4 November 2015

WM Project Number: 13317  
Our Ref: PP04112015\_Ltr\_JW  
Email: jeff@deepriver.com.au

**Re: 25 Martin Road Badgerys Creek - Response to EPA Noise Issues**

Figure C-1 Site Plan showing Barriers & Source Locations – Scenario 1

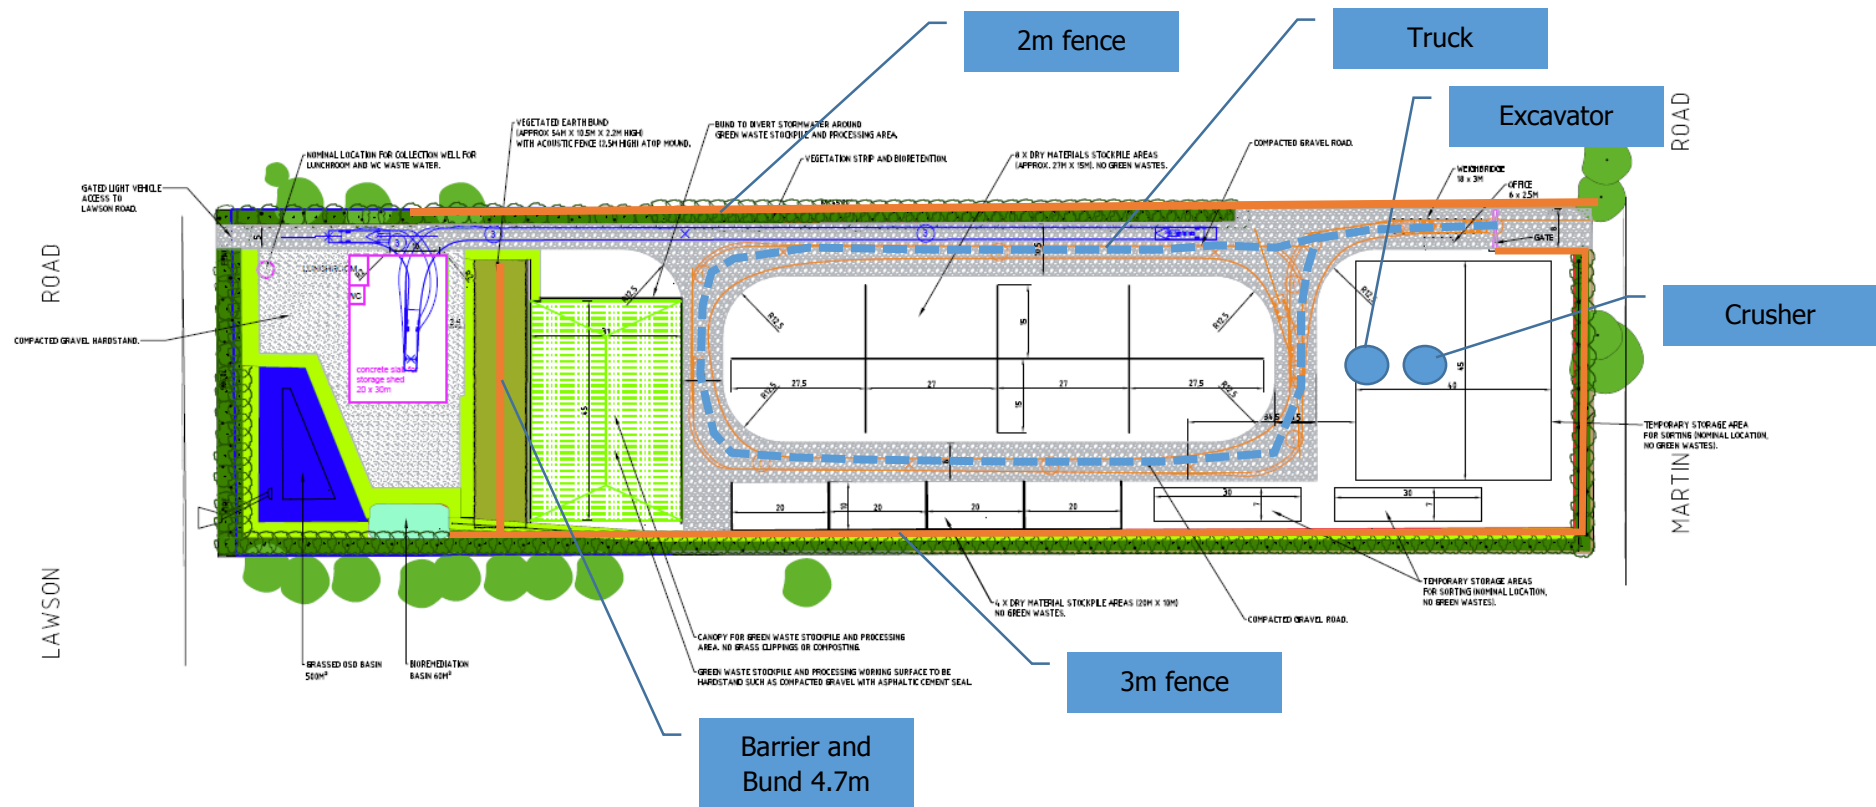
The EPA requires that the assessment details the modelled properties of these shielding structures, and what degree of acoustic shielding they provide, including allowances for flanking noise around barriers and structures.

The EPA requires further information be provided in the Assessment on the locations and heights of the noise sources within the model, and how the predicted noise levels would change for differing noise source placement scenarios.

The EPA required remodelling from the NIA as they were concerned that the model included shielding from acoustically transparent shade cloth structures and additional information was required on source heights and source locations.

Wilkinson Murray mistakenly assumed from aerial photography that the shade cloth structured were buildings. The modelling has been revised without the structures in place and using the revised site plans.

This scenario considers a truck entering the site and unloading building waste adjacent to the temporary stockpile, with an excavator loading the crusher (See Figure C-1). It was assumed that all plant used in the noise model had a source level of 1.5m.
